Technical Review Committee

**CITY OF DELAND
THURSDAY MARCH 20, 2025 AT 1:30 P.M.
CITY OF DELAND TRC MEETING ROOM
DELAND, FLORIDA**

City of DeLand
SP24-198
DUPONT
WAREHOUSE

City of DeLand
SP25-007
HULLEY TOWER,
STETSON

City of DeLand
Z25-024
REZONING FOR
PULTE 472 PD

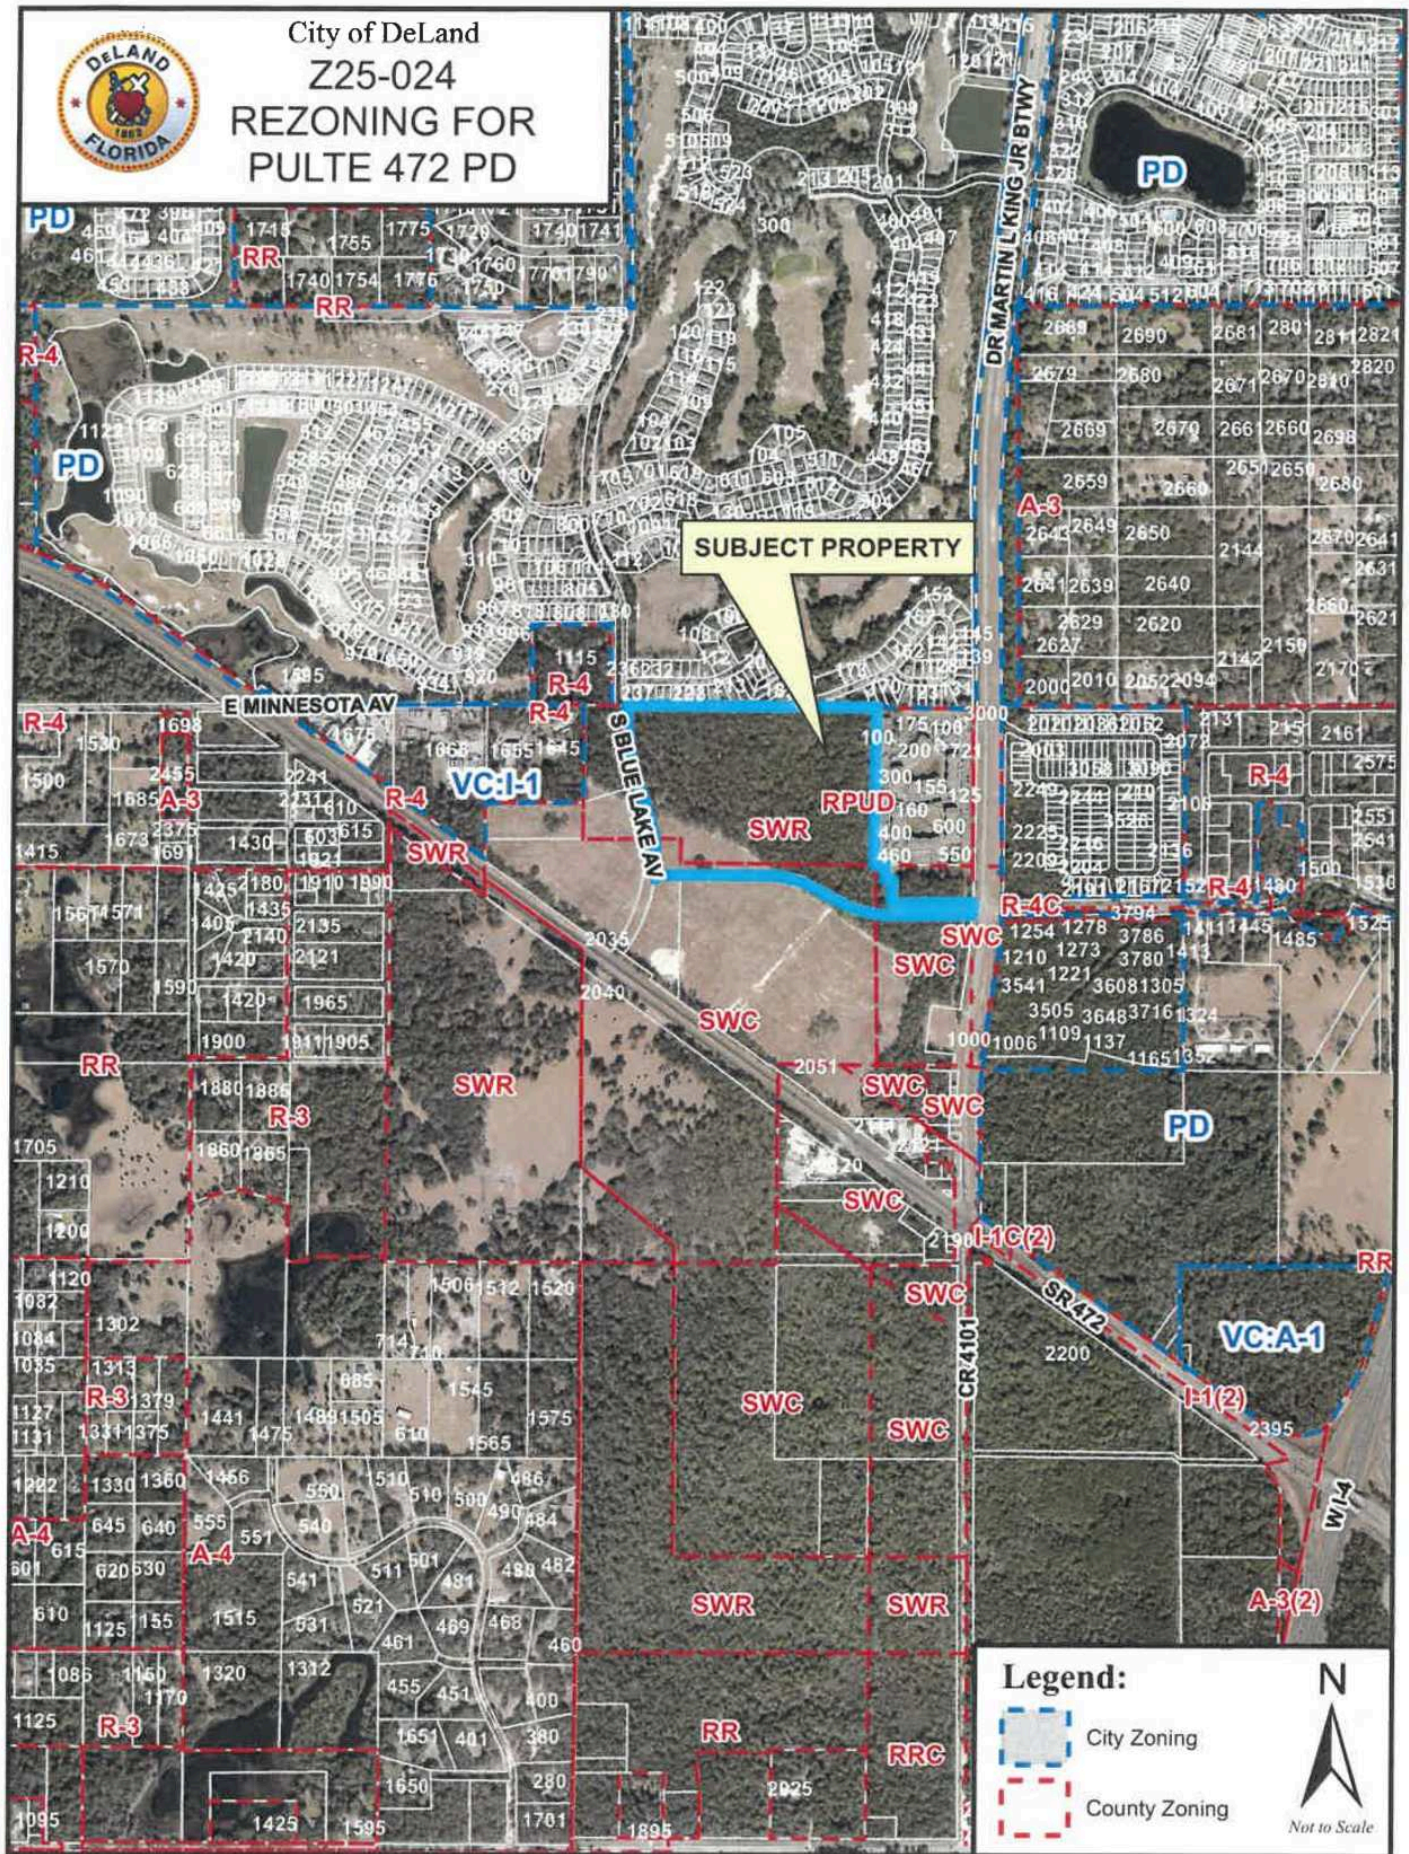
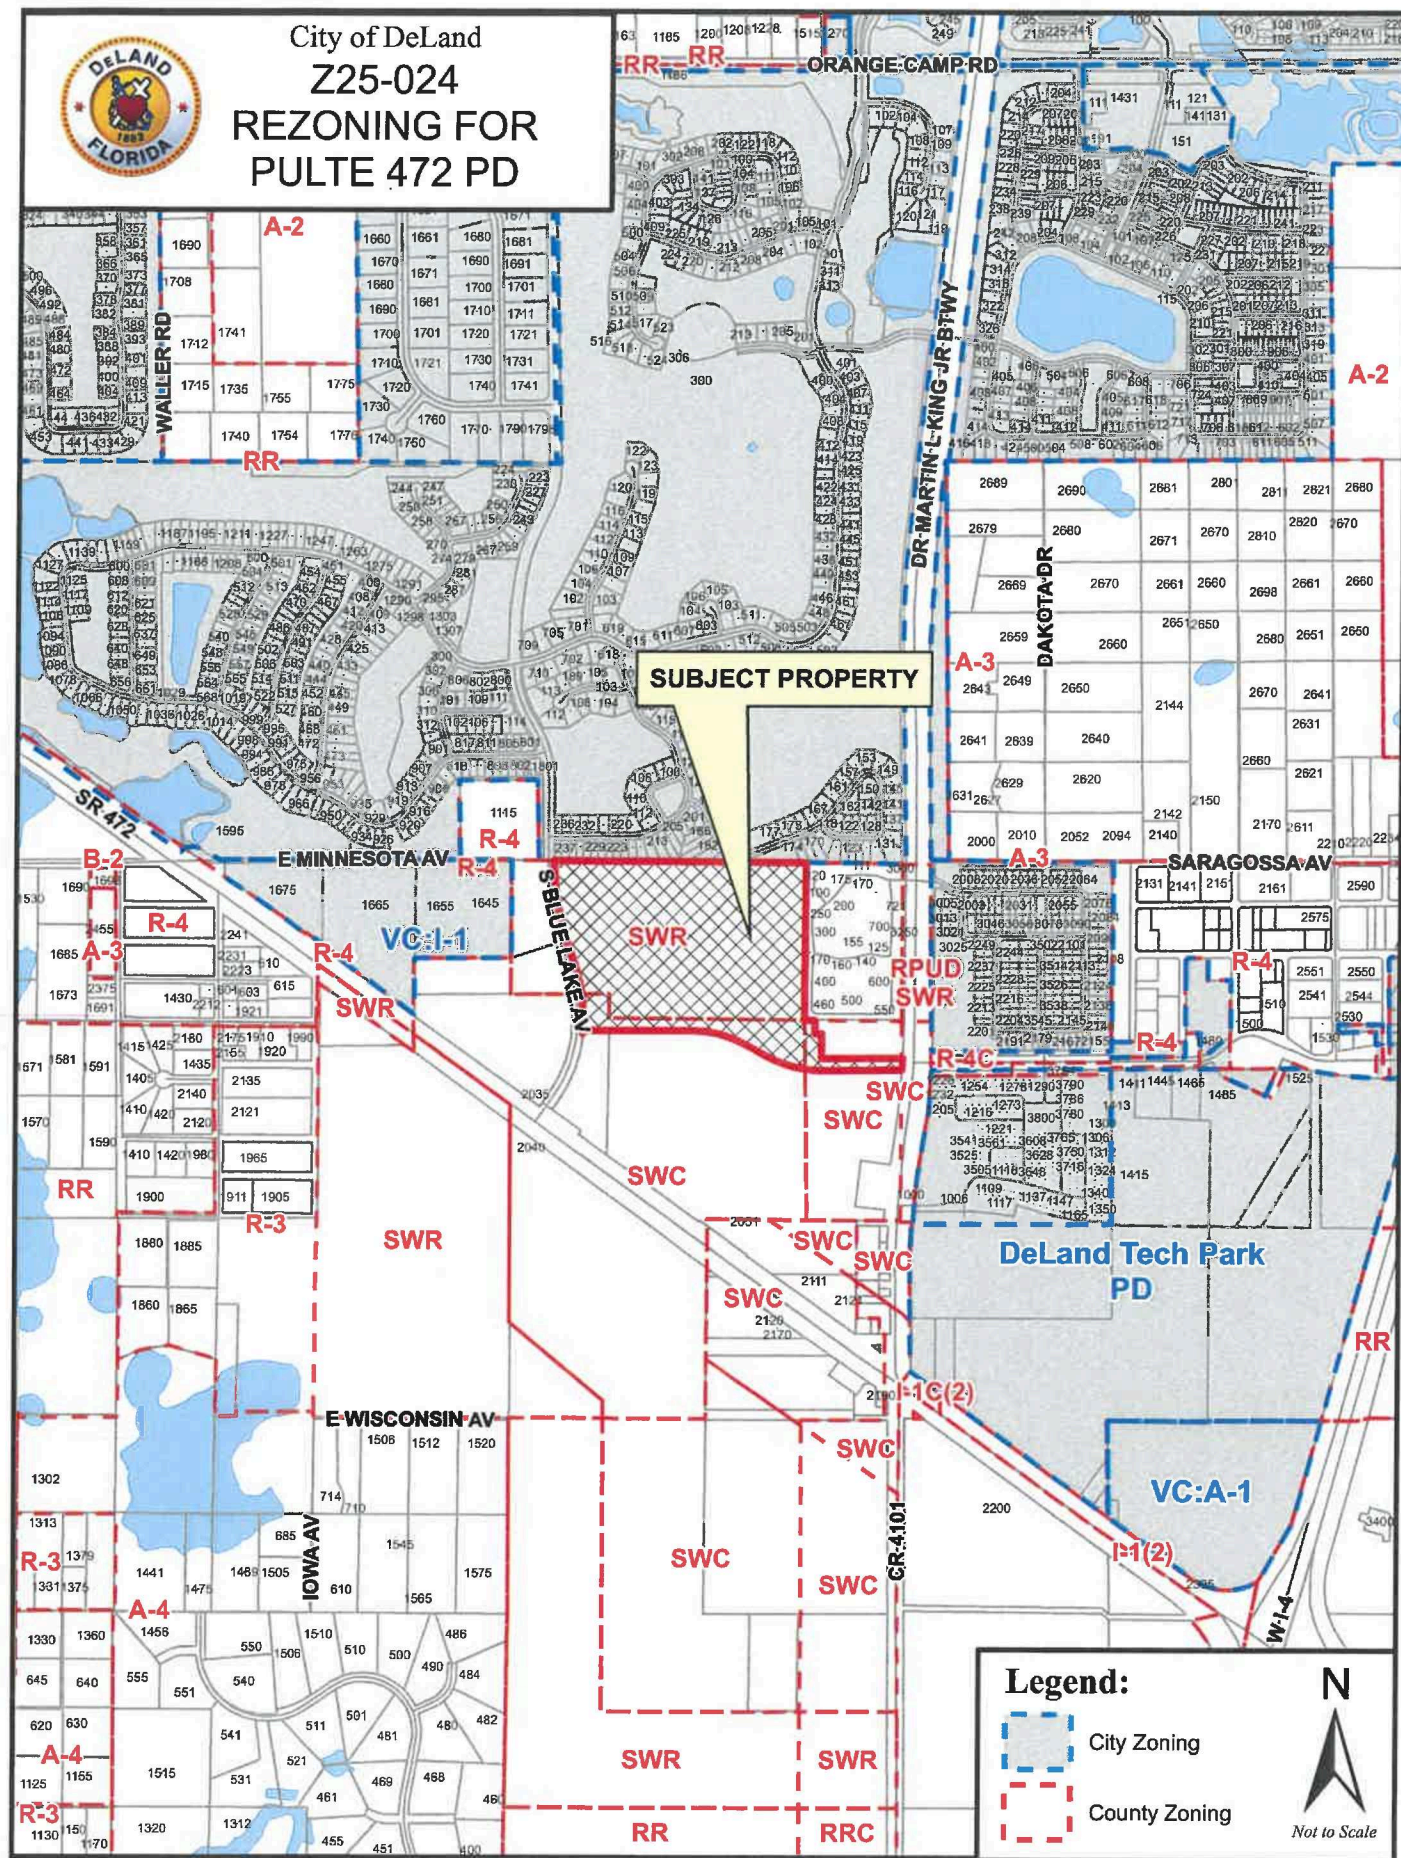
Discipline	Status	Details	Attached To	Created By	Last Updated By	Modifications Required
Engineering	Draft	Stormwater Retention The 100yr/24hr storm event shall be retained on site.	PD Agreement with exhibits-472 PD (2-15-2025).pdf	Steven Danskine	Steven Danskine	Yes
Forestry	Draft	Tree Protection Area Provided Please show how much TPA has been provided. The 39.24 AC project area requires 5.89 AC, and the 1.82 AC offsite stormwater pond requires 0.27 AC.	Ford 472 Overall Plan C-2.0 (rev 12-20-2024).pdf	Kit Dennis	Kit Dennis	Yes
Forestry	Draft	OS-3, OS-1 You are showing OS-3 as a natural vegetation retention area. This may be hard to accomplish due grading that may be necessary for the lots that surround it. OS-1 also includes NVRA that may be encroached in by grading for lots.	Ford 472 Overall Plan C-2.0 (rev 12-20-2024).pdf	Kit Dennis	Kit Dennis	Yes
Forestry	Draft	Tree Protection Area Tracts The Tree Protection Areas will need to be labeled in the tract table. TPA acreage will need to be shown.	Ford 472 Overall Plan C-2.0 (rev 12-20-2024).pdf	Kit Dennis	Kit Dennis	Yes

Discipline	Status	Details	Attached To	Created By	Last Updated By	Modifications Required
			472 PD (2-15-2025).pdf			
Planning	Draft	PD Agreement - Setbacks Not all lots meet the standards defined, for example lots 147, 148 will not meet the 10' side for end units. Refine language to meet. Call out specific lots if you find that is easier.	PD Agreement with exhibits-472 PD (2-15-2025).pdf	Christopher Carson	Christopher Carson	Yes
Planning	Draft	Overall Plan - C2.0 Make sure the standards from the overall Plan match the PD.	Ford 472 Overall Plan C-2.0 (rev 12-20-2024).pdf	Christopher Carson	Christopher Carson	Yes
Planning	Draft	Overall Plan - C-2.0 Revise "City PUD" to "City PD"	Ford 472 Overall Plan C-2.0 (rev 12-20-2024).pdf	Christopher Carson	Christopher Carson	Yes
Planning	Draft	Overall Plan - Lot Area Break this down into Single Family, Multifamily or revise to say "Residential"	Ford 472 Overall Plan C-2.0 (rev 12-20-2024).pdf	Christopher Carson	Christopher Carson	Yes

Planning	Draft	Overall Plan - Lighting Modify to clarify that Lighting will be in accordance with the Community Design Standards in S. 33-94. (Will not exceed 0.5 foot-candles at the property line)	Ford 472 Overall Plan C-2.0 (rev 12-20-2024).pdf	Christopher Carson	Christopher Carson	Yes
Planning	Draft	PD Agreement - Stormwater Call out 100 year, 24-hour design criteria. Simplify verbiage. Let's remove phasing language as all site work will already be complete.	PD Agreement with exhibits-472 PD (2-15-2025).pdf	Christopher Carson	Christopher Carson	Yes
Planning	Draft	PD Agreement - Signage revise from "may be internally lit" to "shall be internally lit".	PD Agreement with exhibits-472 PD (2-	Christopher Carson	Christopher Carson	Yes

Utilities	Draft	USA A Utility service Agreement was drafted and sent previously, when in the VC but not signed and returned.	Ford 472 Overall Plan C-2.0 (rev 12-20-2024).pdf	Jim Ailes	Jim Ailes	Yes
Utilities	Draft	Connections Water, Sewer, and Reclaim connections were completed with the VC review unless changes are made.	Ford 472 Overall Plan C-2.0 (rev 12-20-2024).pdf	Jim Ailes	Jim Ailes	Yes
